Re: Automobili LAMBORGHINI S.p.A. - Defect Information Report

**DEFECT INFORMATION REPORT**

Pursuant to 49 C.F.R. Section 573.5, Automobili LAMBORGHINI S.p.A. hereby submits the following Defect Information Report concerning LAMBORGHINI's 1996 and 1997 Diablo Roadster models :

### INSPECTION/REPLACEMENT PROCEDURE FOR THE WINDOW RETRACTION/DOOR LOCK ASSEMBLY ON 96&97 ROADSTERS

INSIDE DOOR LATCH ASSEMBLY #1

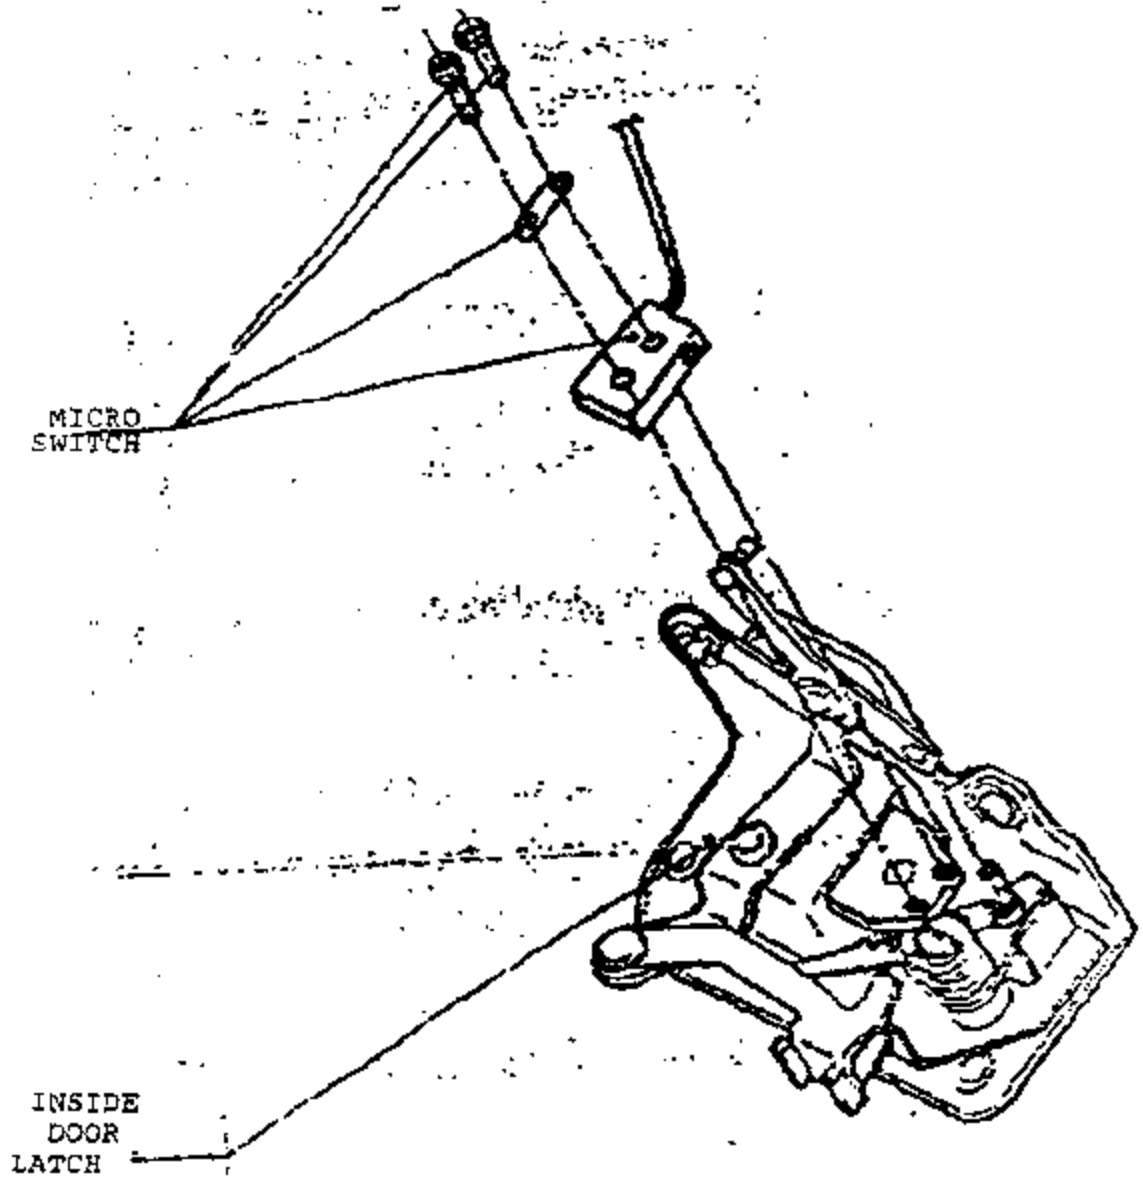
Through Investigation and Testing we have determined that in some of the vehicles referenced above, the Micro Switch circuitry has failed because the connection to the Inside Door Latch was not properly made during initial assembly. We believe that the failures are generated by this improper connection of the Micro Switch to the Inside Door Latch during assembly. Therefore, only vehicles with an improper connection need to be repaired.

We will inspect all vehicles within the above referenced production range to find those with an improper connection and replace the Micro Switch and Inside Door Latch on those vehicles with the modified components that have proven to be much easier to assemble and install correctly.

# DRAWING "A"

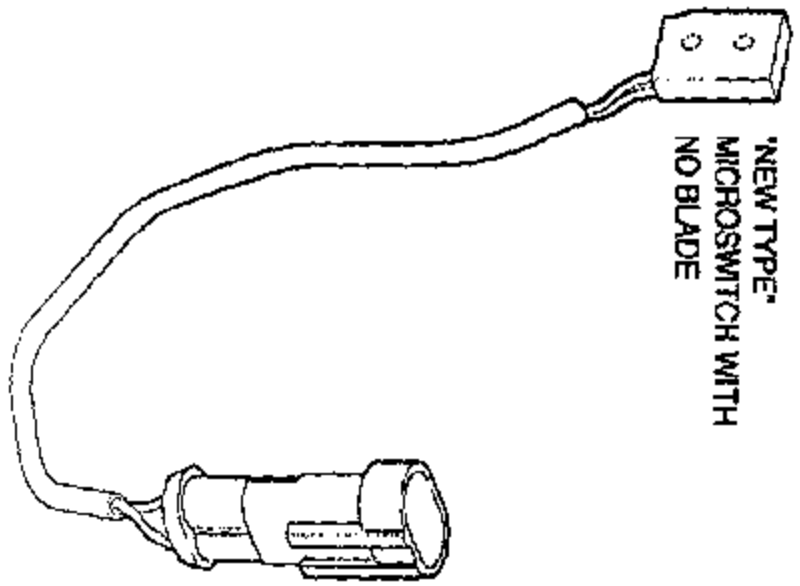
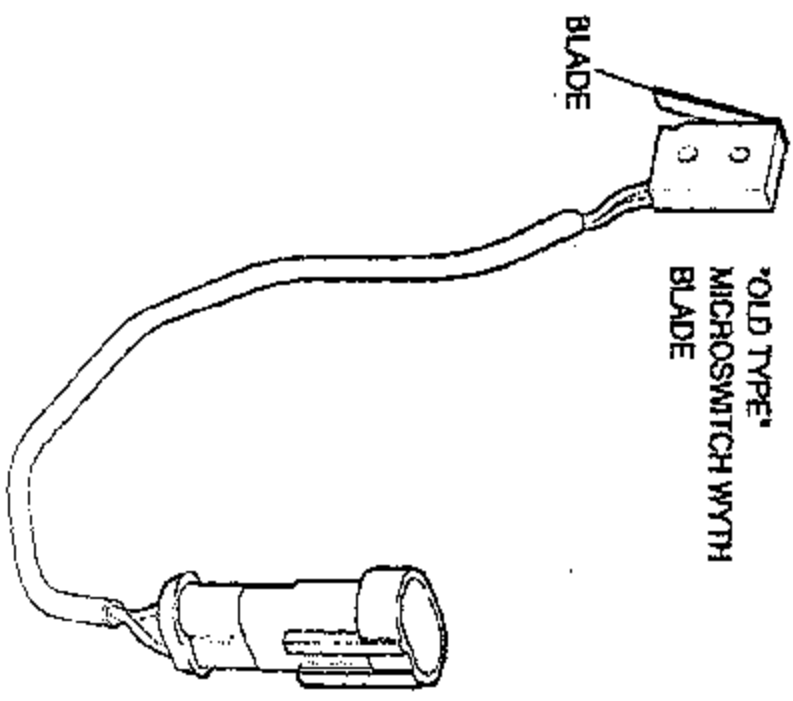
A) in case of a "new type" lock (see drawing "A") and a positive result of the check

B) in case of a "new type" lock (see drawing "A") and a negative result of the check made in step 010 - follow the instructions given in steps 290 to 420;

C) in case of an "old type" lock (see drawing "A") - follow the instructions given in steps 130 to 420

- 230 Compare the old lock assembly with the New lock assembly (which includes a New microswitch), adjust the lever positions on the New assembly to match those of the old assembly, thereby allowing an installation with the lever connections at the proper position;

- 240 Install the new lock assembly with the closing lever, lower gasket and external reinforcement onto the door. Accurately adjust the external reinforcement position with specific shims to avoid any damage to the paint. Apply a medium thread locking product (Loctite 242 or Arexons System 52A42) to the mounting screws.
